Rio Algom Mining LLC

Re: Requested Supplemental Information

Rio Algom Mining LLC - Environmental Sampling Locations (Former & Current)

Figure 1. Map of high-volume, sediment, and direct gamma sampling locations at RAML's Ambrosia Lake Valley facility.

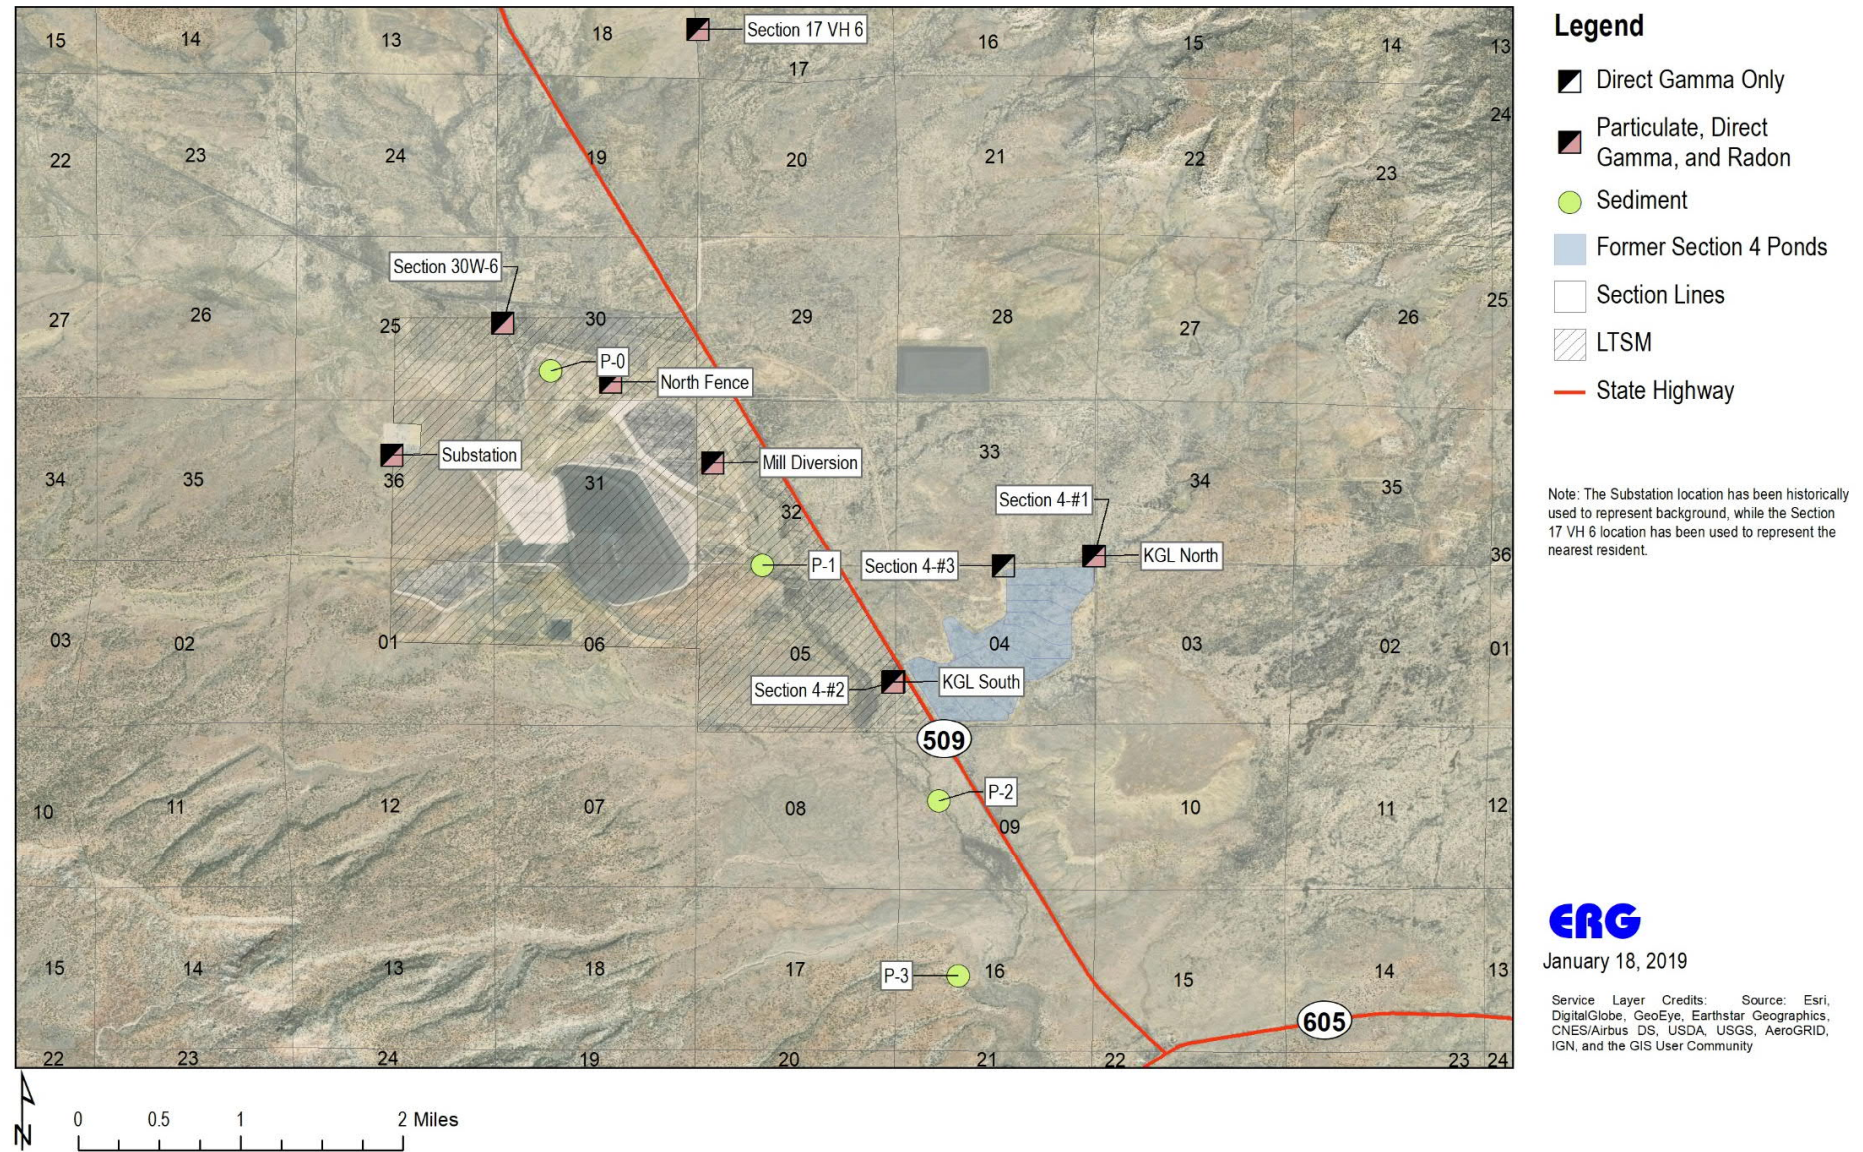
1. Clarification of the nomenclature around environmental monitoring locations KGL North, KGL South, and Section 4 Nos. 1-3.

3. A map of historical sediment sampling locations.

A map depicting particulate, direct gamma, and sediment sampling locations is provided as Figure 1.

Monitoring locations KGL North and KGL South were added during the fourth quarter of 2005 as part of an expansion of RAML's environmental monitoring program during the section 4 ponds reclamation project. These stations monitored air particulates (high-volume continuous air monitoring), direct gamma (environmental dosimeters), and radon-222 (track etch detectors).

In the first quarter of 2008, the two existing section 4 pond direct gamma monitoring locations were renamed Section 4 - #1 (previously KGL North) and Section 4 - #2 (previously KGL South). Additionally, a third monitoring location Section 4 - #3 was added. Radon and particulate monitoring locations continued to be reported as KGL North and KGL South. All three direct gamma monitoring locations are displayed in Figure 1.

A map depicting particulate, direct gamma, and sediment sampling locations is provided as Figure 1.
